# MANUAL CHANGES

Model Number: 8690B-H26  
 Date Printed: March 1969  
 Part Number: 08690-91004

This supplement contains important information for correcting manual errors and for adapting the manual to instruments containing improvements made after the printing of the manual.

Figure 1. Model H26-8690B Rear View (Part of Change 1)

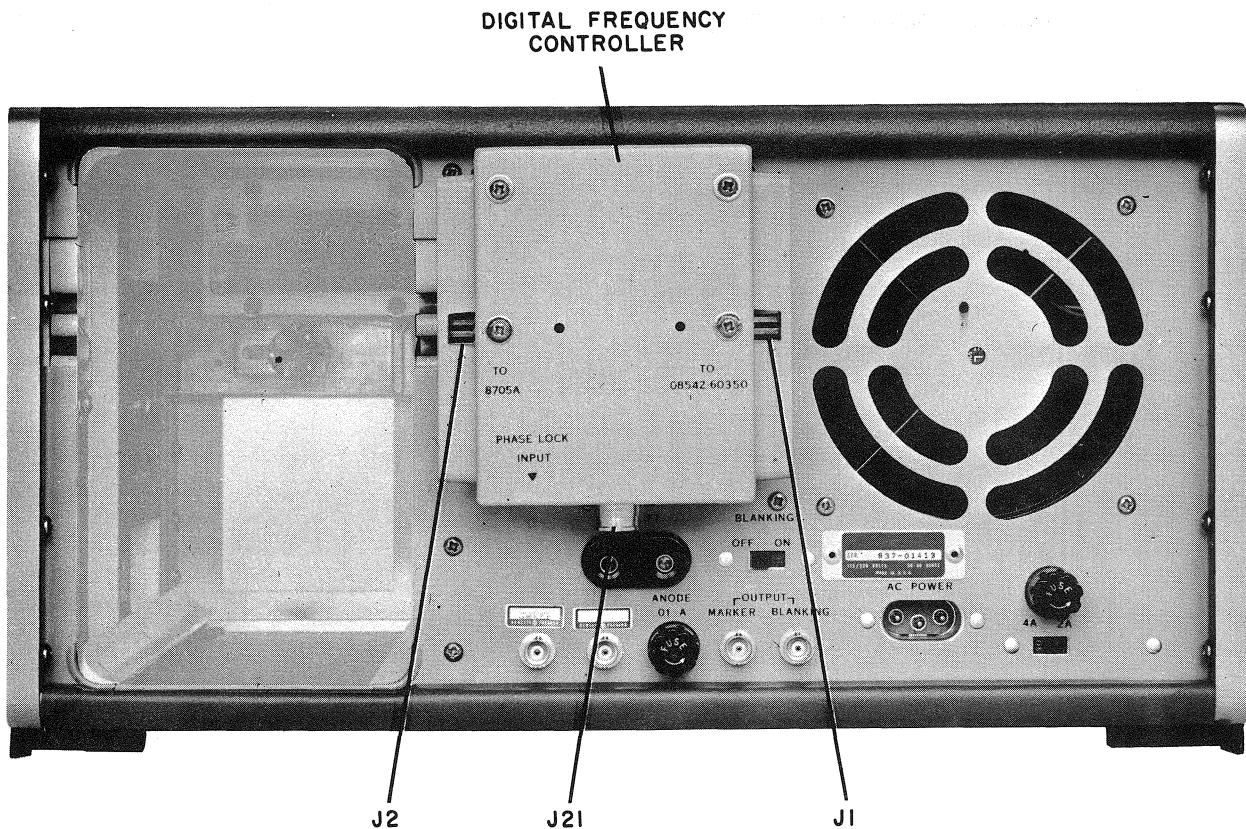
Page 1, Figure 1:

Replace figure in manual with attached Figure 1.

Page 3 of this Change Sheet, Figure 1:

Add a BNC connector to the left of the SWEEP connector. Label the new connector TUN VOLTAGE. The connector transmits the tuning voltage to the 85405A Control Unit in the 8543A Automatic Network Analyzer.

*Figure 4. Digital Frequency Controller Interior View (Part of Change 1)*

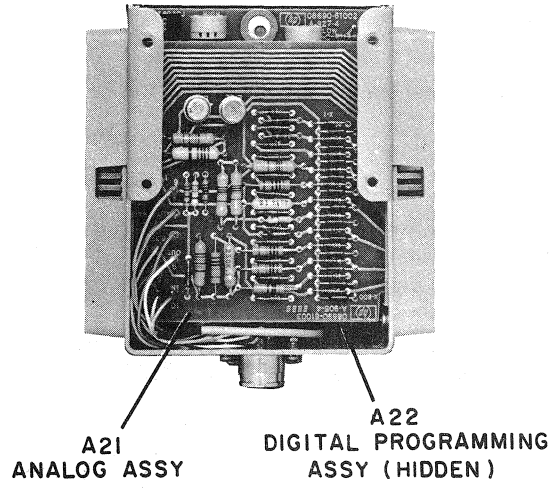
Page 4, Figure 4:

Replace figure in manual with attached Figure 4.
